SASSARIXA SWAMP MITIGATION PLAN

Johnston County, NC
NCDEQ Contract No. 7425
DMS ID No. 100040

RE: Sassarixa Swamp Mitigation Site – NCIRT Comments during 30-day Mitigation Plan Review
Sassarixa Swamp Mitigation Site (USACE AID# SAW-2018-00432, NCDMS # 100040)
Neuse 03020201, Johnston County, NC

3.2
Sheet

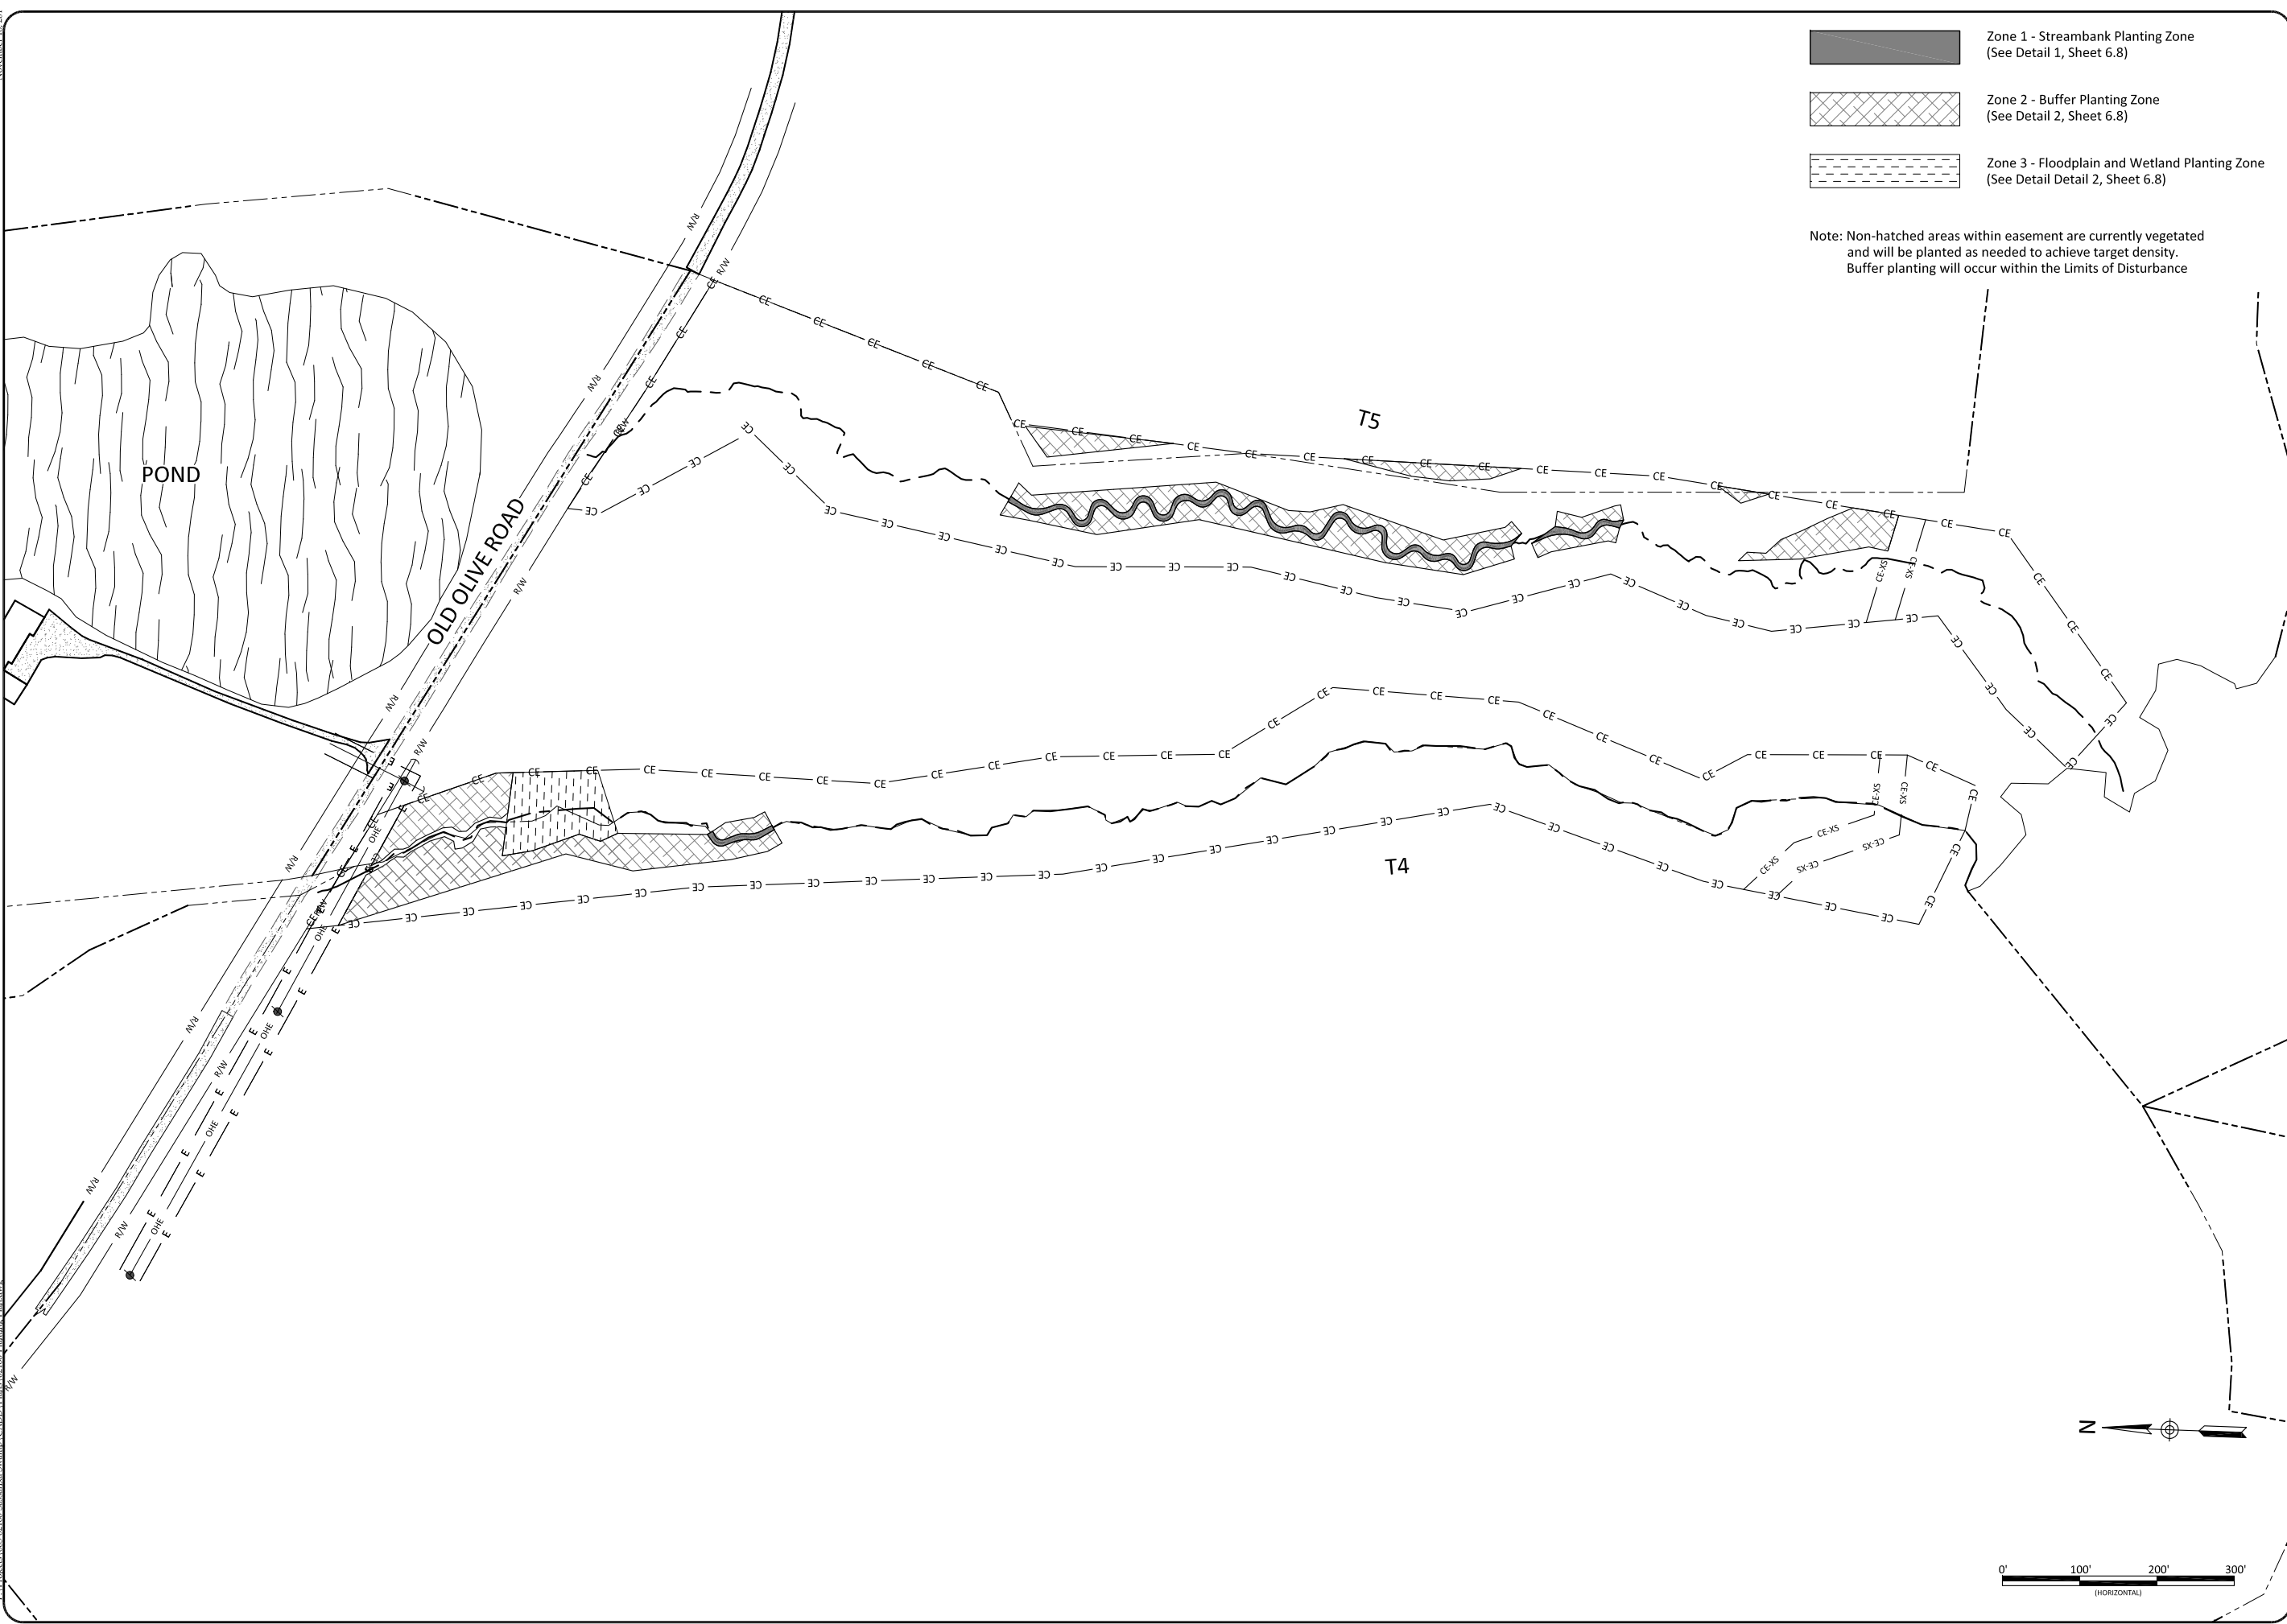
6. Planting Plan, Design Sheet 3.2 – does not depict reach T1D.

T1D has been added to Sheet 3.2.

5.0

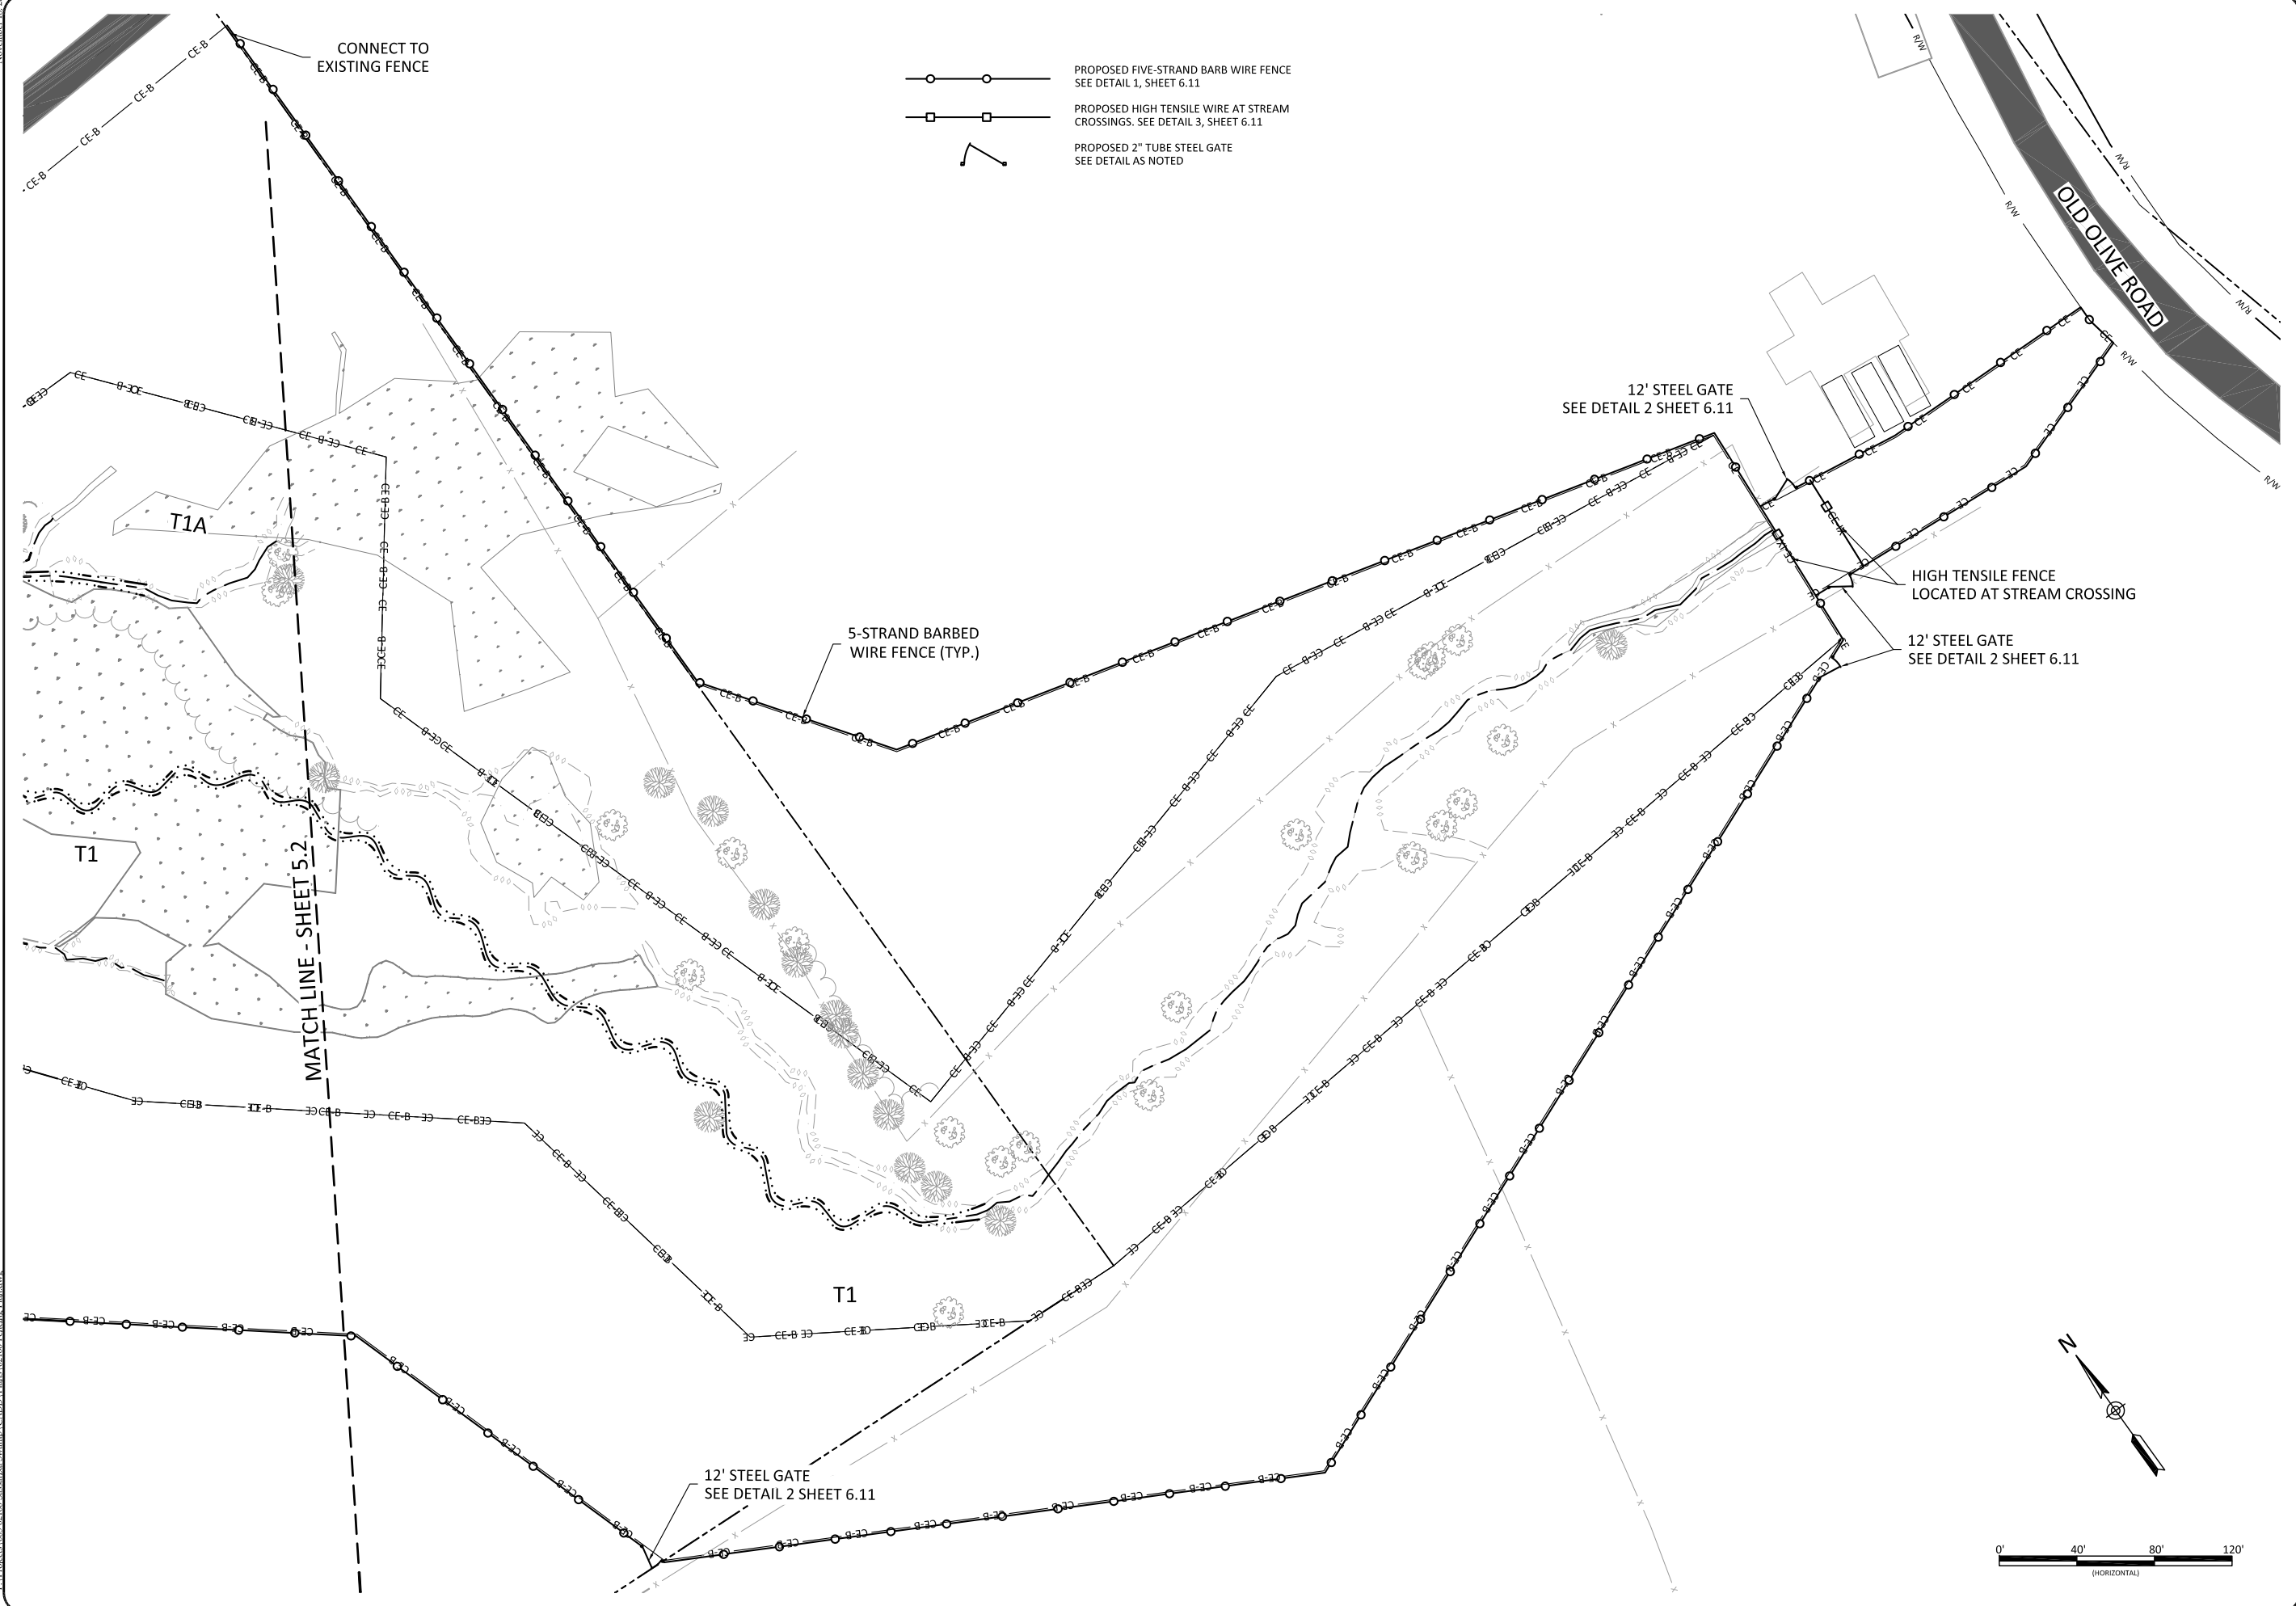
12. Fencing is only proposed on the left side of Sassarixa Creek as shown on plan sheets 5.0-5.3. No existing or proposed fencing is shown on the right side/bank. However, there is an internal crossing proposed on Sheet 1.2. If this crossing is to give cattle access to the other side of Sassarixa in the future, there needs to be fencing installed on the left side/bank of Sassarixa Creek as part of this Plan.
